Opel Corsa-D - Front brake system

Front brake system

Squeaking noises when braking

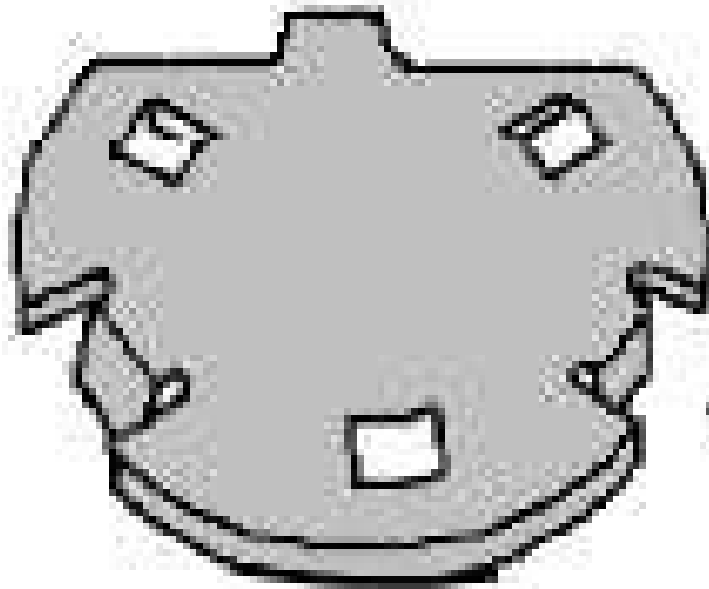
If the symptom specified above cannot be allocated to any detectable defect on the wheel brake, one possible cause of this is an insufficient decoupling between the brake pad and the brake caliper. For improving comfort, the vehicle manufacturers have installed so-called "Piston Caps" in the piston (A) of the brake calipers.

These additional "Piston Caps" (B) have been introduced to the production from the following chassis numbers.

In case of a complaint, this must be checked and renewed where appropriate. On vehicles affected without "Piston Caps", these can be retrofitted.

Spare part number "Piston Cap": Opel 93169307
